# JONES & BEACH ENGINEERS INC.

**RE: Response Letter 4 –TAC Comments**  
**212, 214, & 216 Woodbury Ave., Portsmouth, NH, 03801**  
**Tax Map 175, Lots 1, 2, & 3**  
**JBE Project No. 21254**

We are in receipt of comments from Stefanie Casella, Portsmouth Planning Department, dated December 30, 2022 as well as comments from Eric Weinrieb, Altus Engineering, dated January 11, 2023. Review comments are listed below with our responses in bold.

DRAWING No.	C2
SHEET 5 OF 23	JBE PROJECT NO. 21254

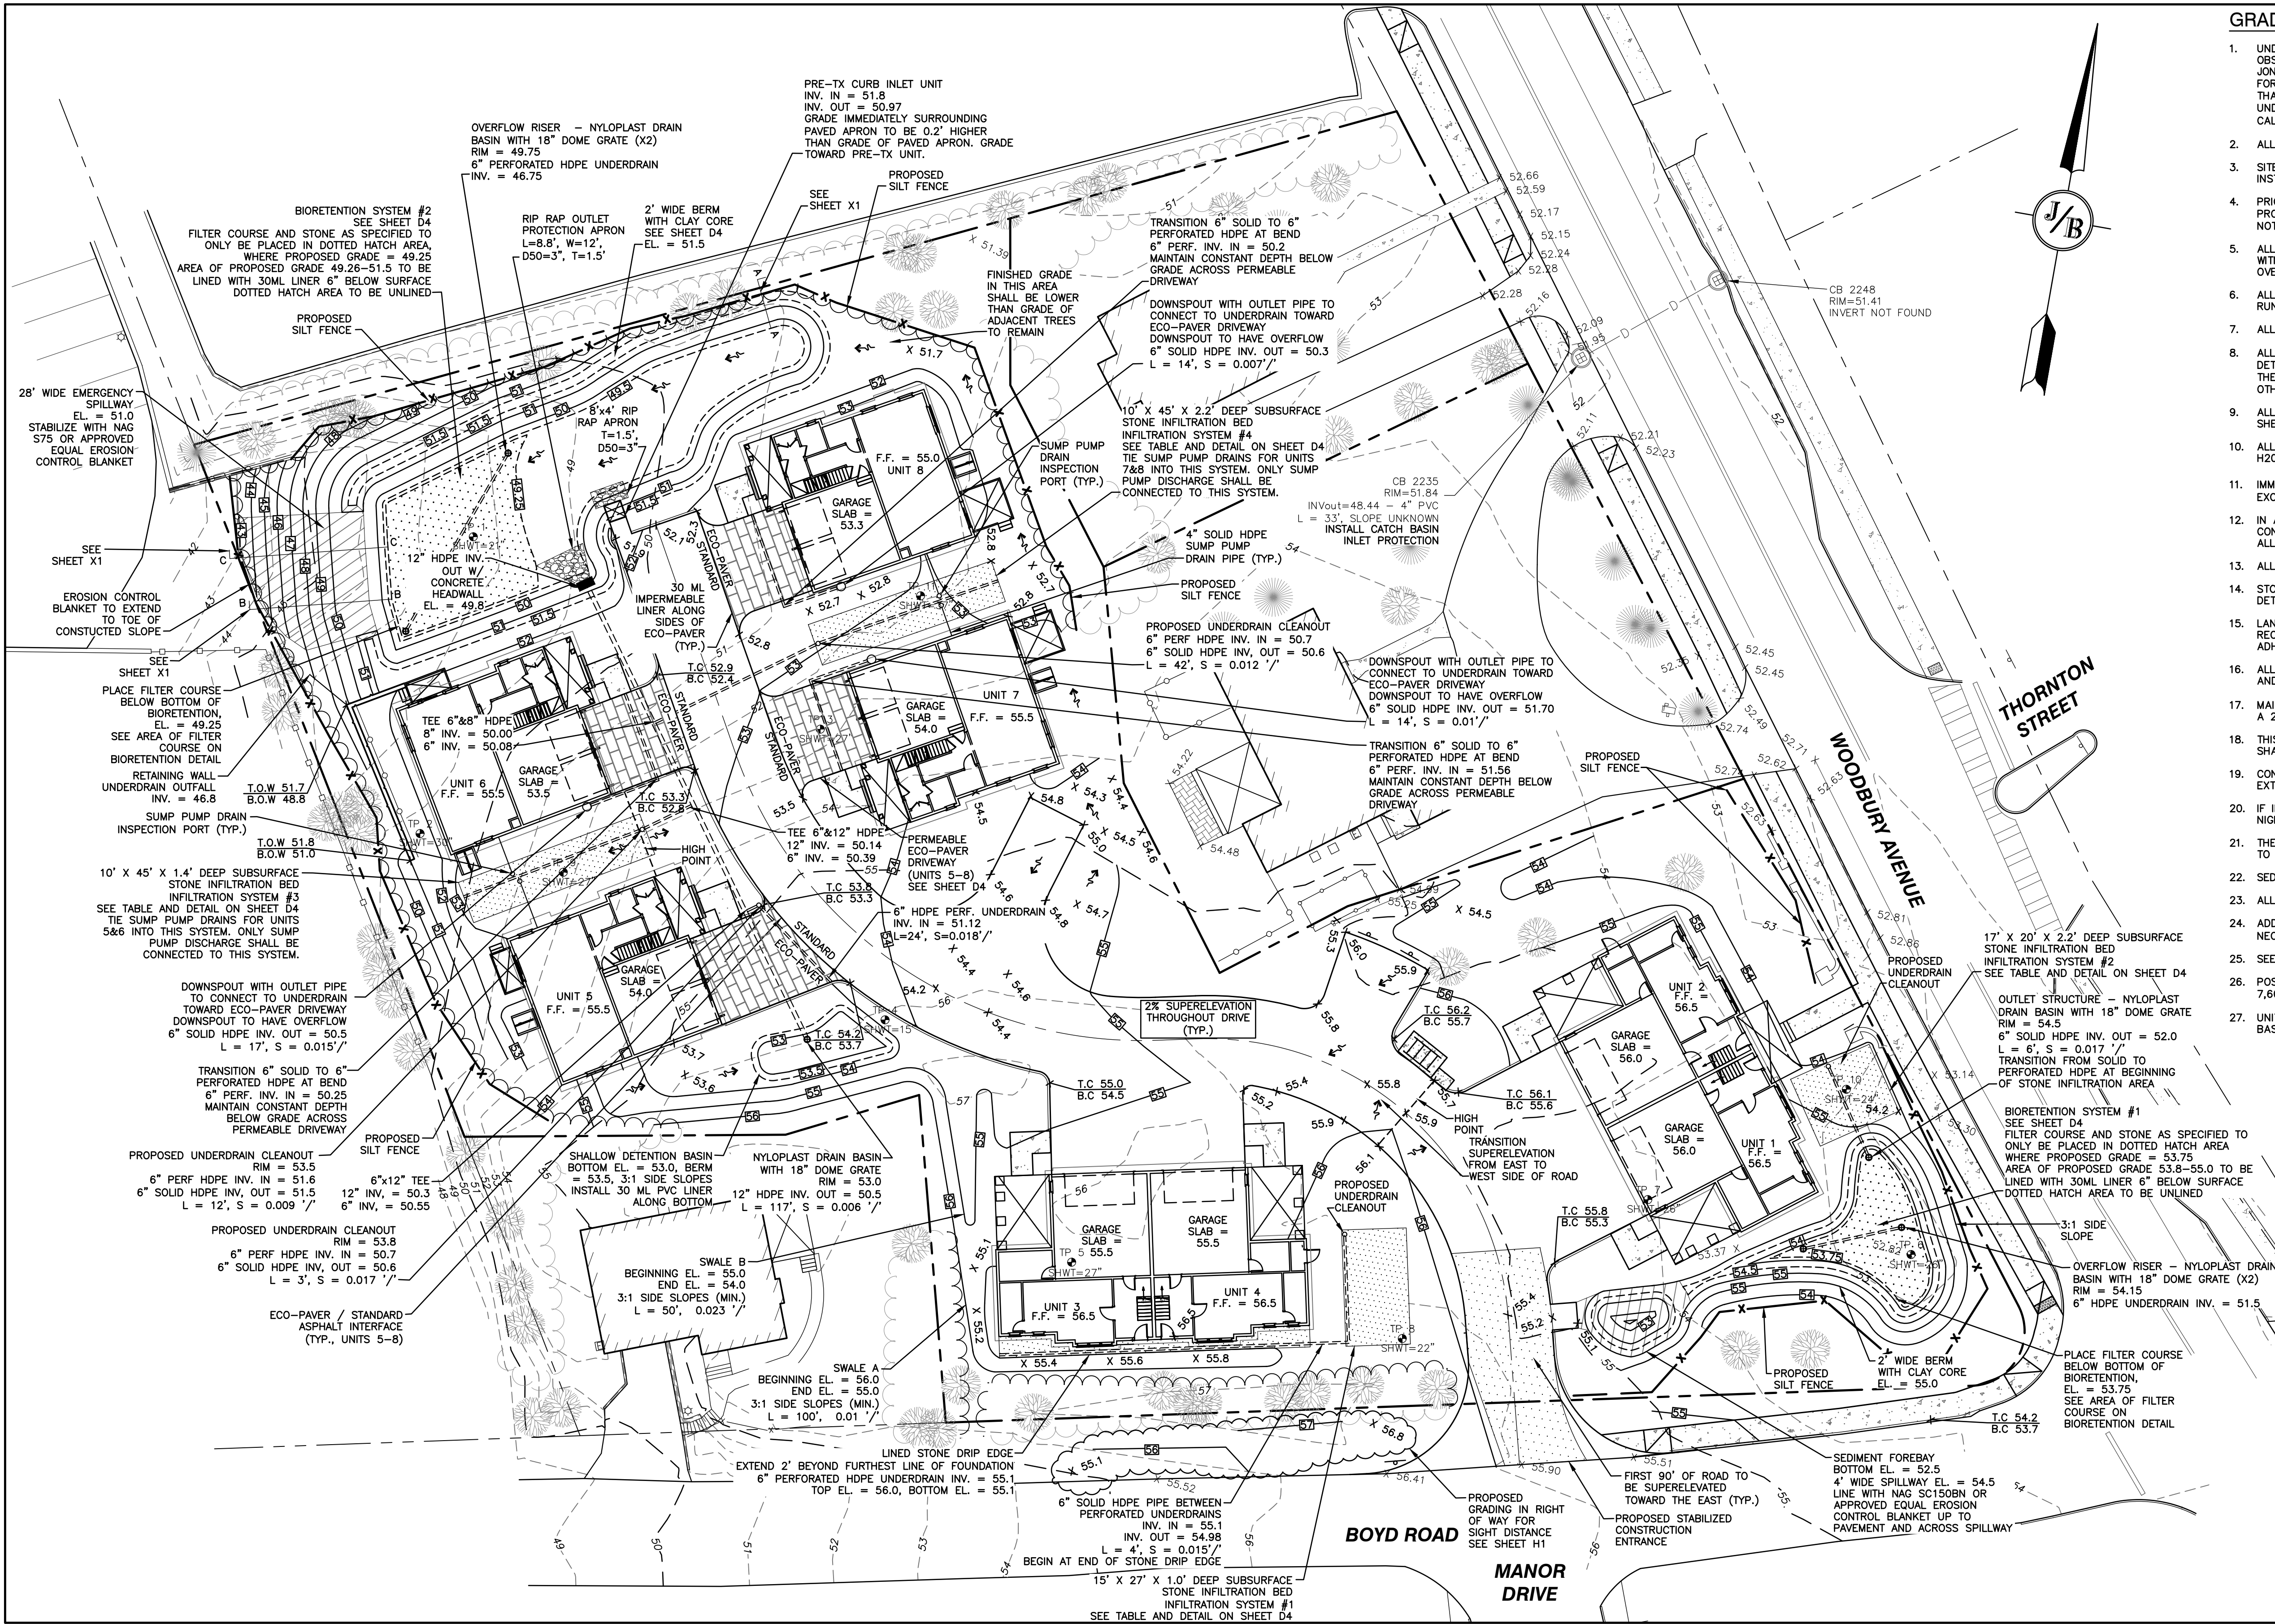
4. *The sidewalk should terminate at the driveway entrance to the hotel. Please clarify the proposed sidewalk notes to indicate that.*  
**RESPONSE: The sidewalk has been revised to terminate at the driveway entrance to the hotel. Sheet C2 now shows this and calls it out.**

5. *If Boyd Road is reconstructed (due to happen in this coming construction season) prior to the site work in Boyd Road being constructed, Boyd Road will require a mill and fill pavement resurfacing for all disturbed areas to the satisfaction of the DPW.*

6. *Please smooth out the proposed curb alignment on Boyd Road near the intersection of Woodbury.*

**RESPONSE:** See Note #30 on Sheet C2.

**RESPONSE:** The jog that was shown in the proposed curb has been removed.

DRAWING No.	L1
SHEET 10 OF 23	JBE PROJECT NO. 21254

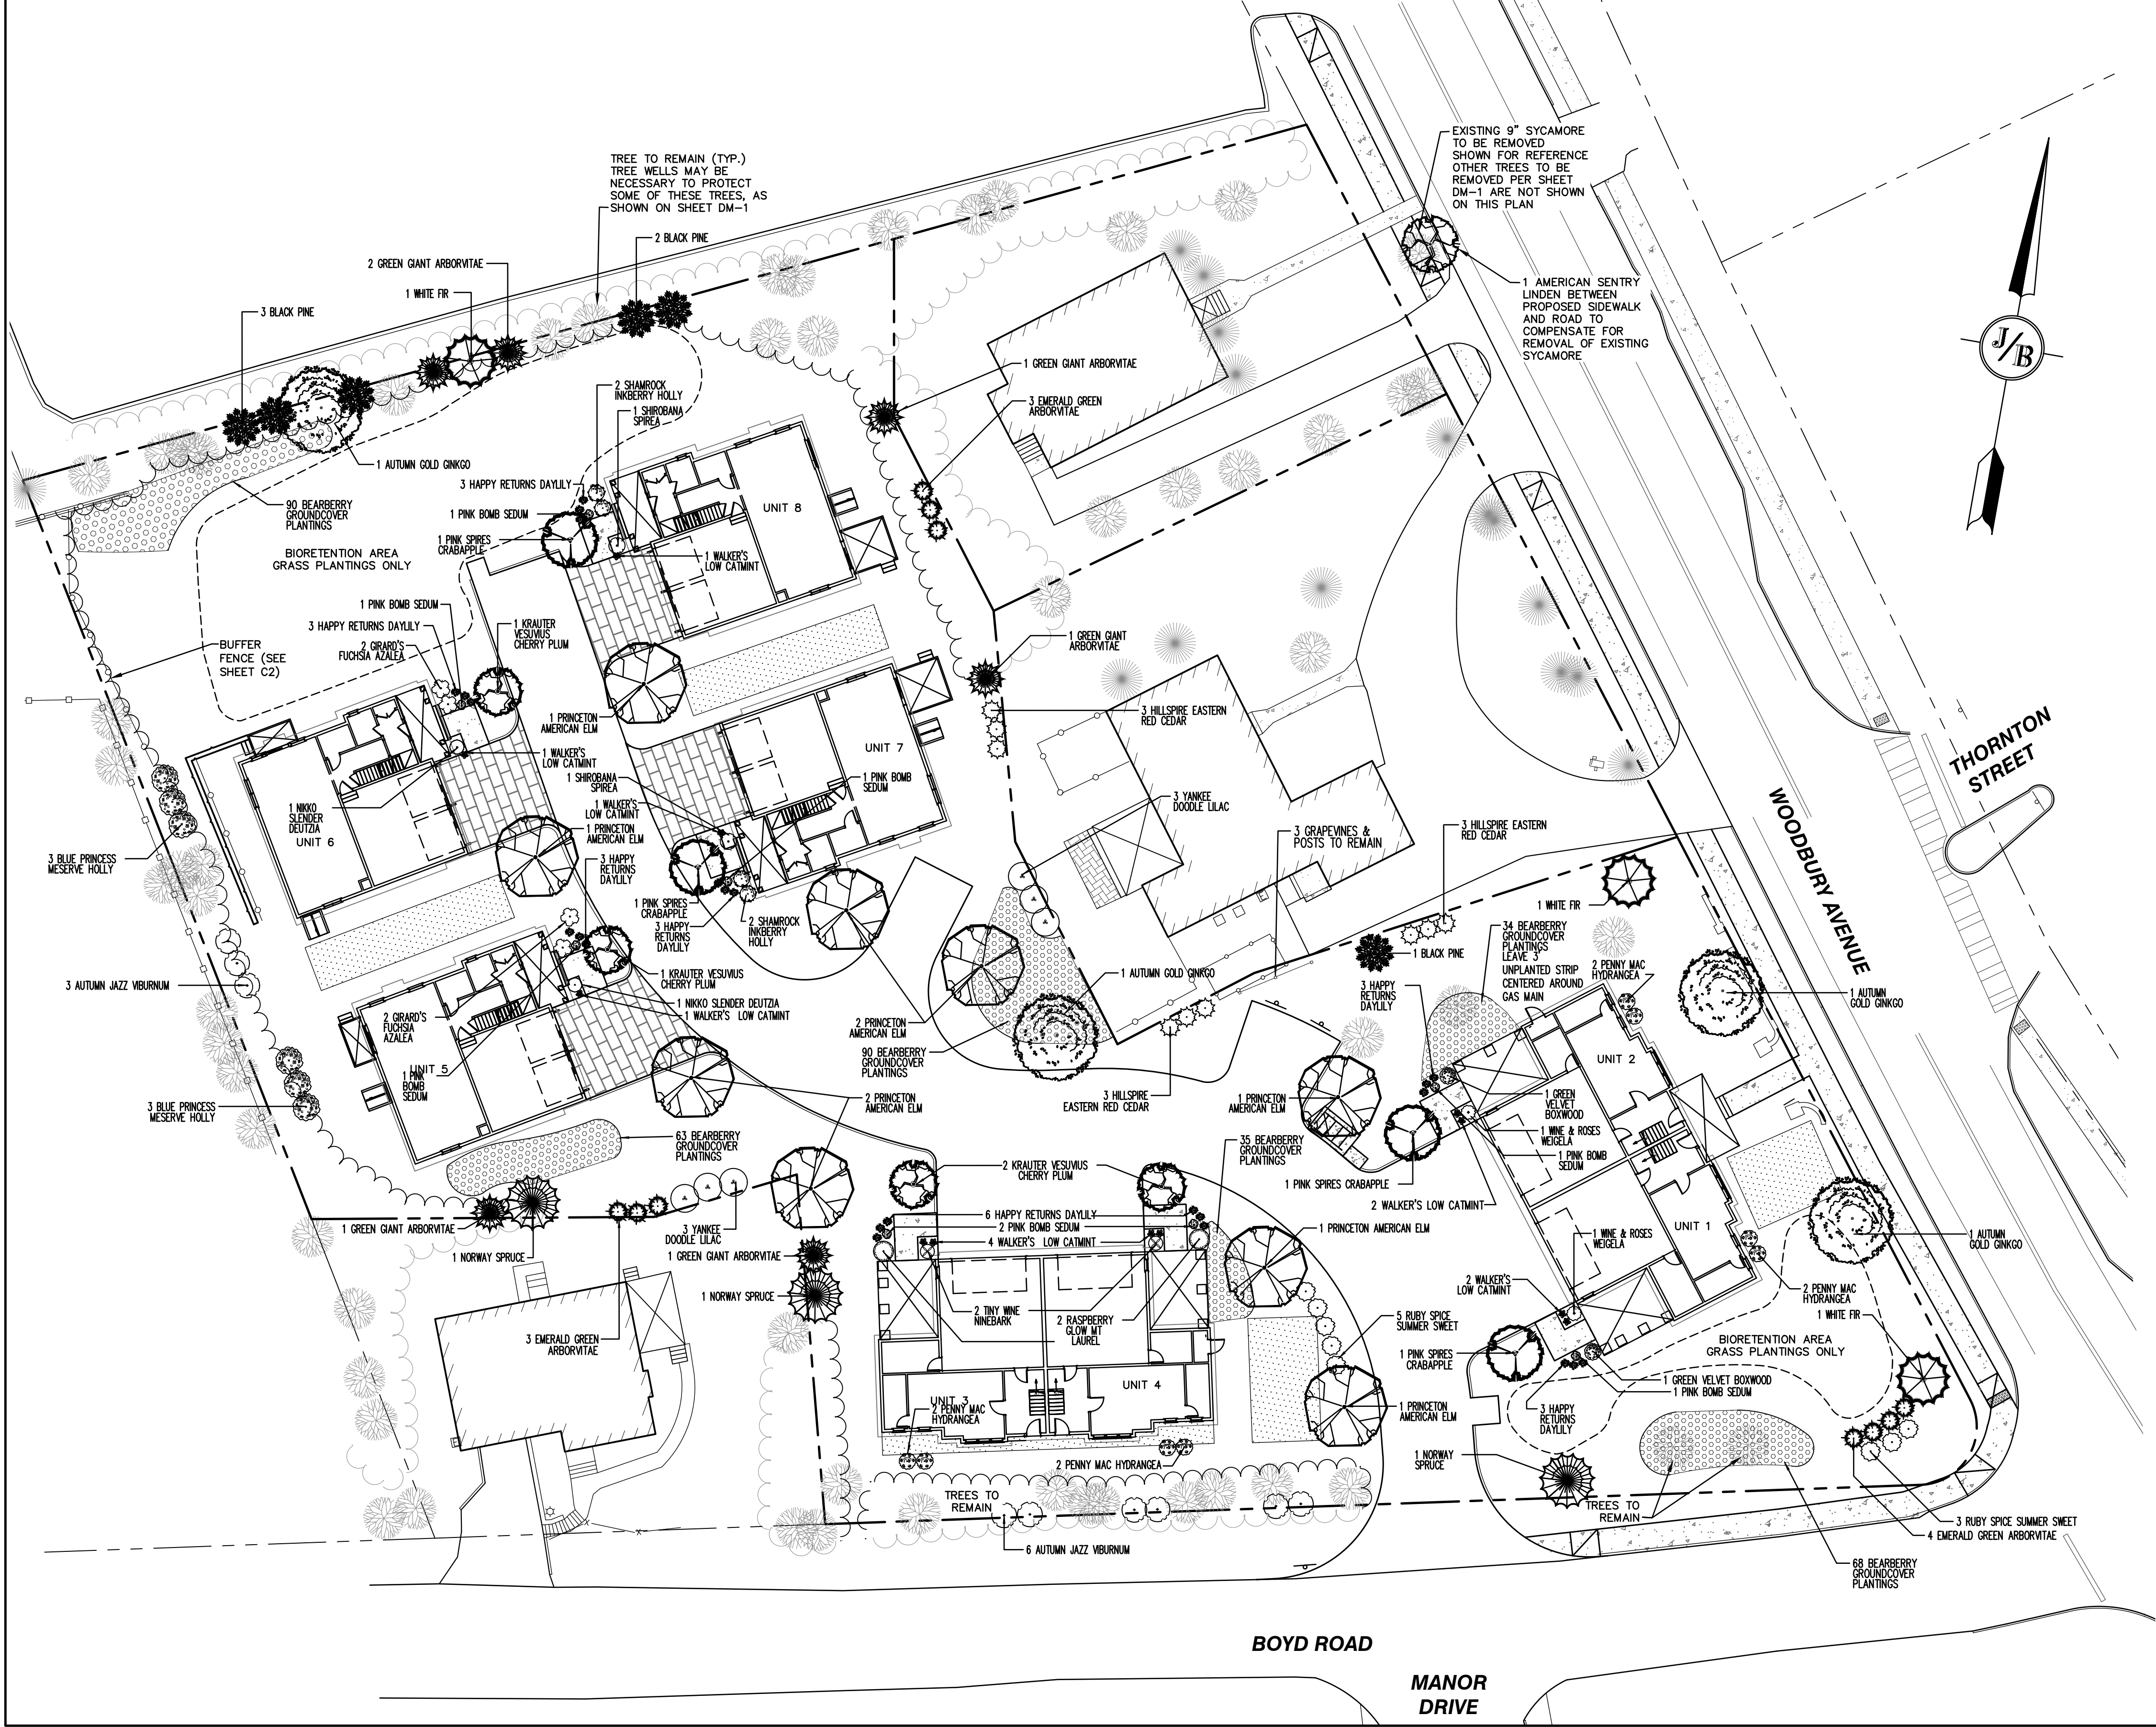
3. *The 9" 'Sycamore' (London Plane) tree in front of 216 Woodbury will need to go before Trees and Greenery for permission to remove. The tree should be replaced with a suitable species.*

18. *Property owner should consider plant irrigation for the first two years of growth (Note 7 Sheet L1).*

19. *Please identify areas where protective groundcover measures could be applied in lieu of grass, mulch is also not considered a groundcover. Managed turf areas should be kept to a minimum to reduce mowing and fertilizer needs. (Note 8 Sheet L1).*

20. *Staff recommends requiring the applicant plan for at least two years of monitoring and maintaining the new plantings. If after one year the plantings do not have at least an 80% success rate, replanting will be required. (Note 19 Sheet L1).*

22. *Include smart controllers for the planned irrigation of landscaped areas for more efficient use of water resources – see site plan review regulation 6.11.2. Please also consider using recycled water when possible for irrigation needs.*

**RESPONSE: We are applying to Trees and Greenery for approval and the Trees and Greenery request letter is going directly to DPW. The Planning Department will be copied via email on this submission. As shown on Sheet L1, the sycamore is proposed to be replaced with a 3" caliper American Sentry Linden, which is narrow and will avoid the utility wires.**

**RESPONSE:** This verbiage has been added to Note 7 on Sheet L1.

**RESPONSE:** Bearberry is now proposed in several areas of the site. This is a native spreading groundcover that would provide a shallow rooting mat over these areas.

**RESPONSE:** See Note #24 on Sheet L1.

**RESPONSE:** See Note #25 on Sheet L1.

DRAWING No.
D1
SHEET 12 OF 23 JBE PROJECT NO. 21254

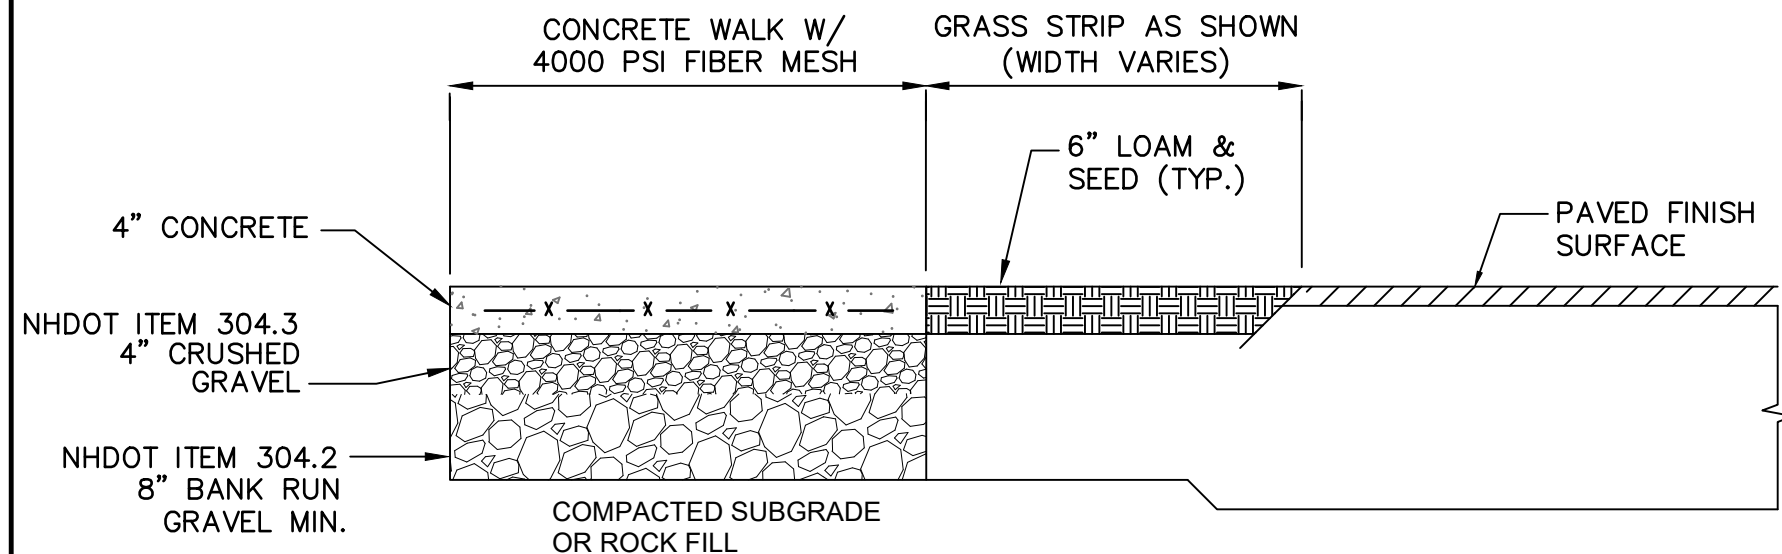
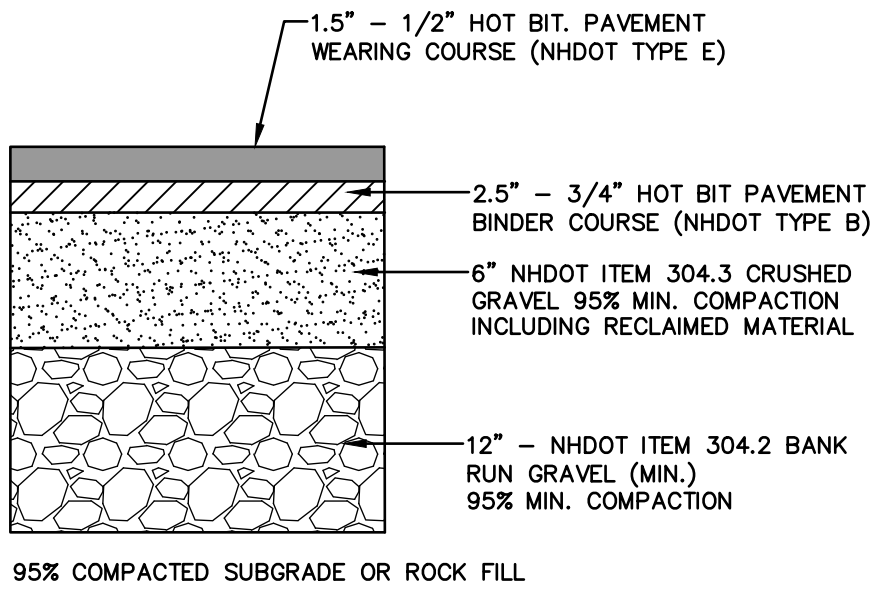
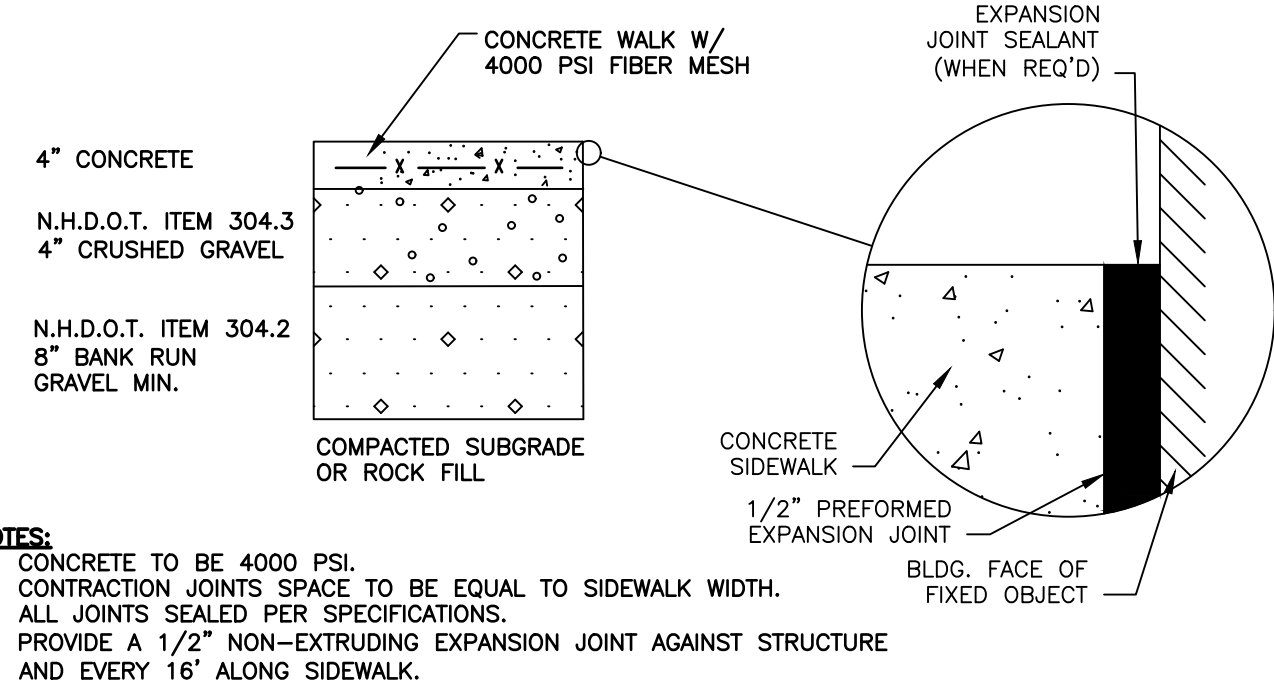
8. *No welded wire shall be used in any sidewalks in the City's ROW. Use 4000psi fiber-mesh instead.*

**RESPONSE:** The details have been revised to call for a 4000 psi fiber mesh instead of welded wire reinforcement within the sidewalk.
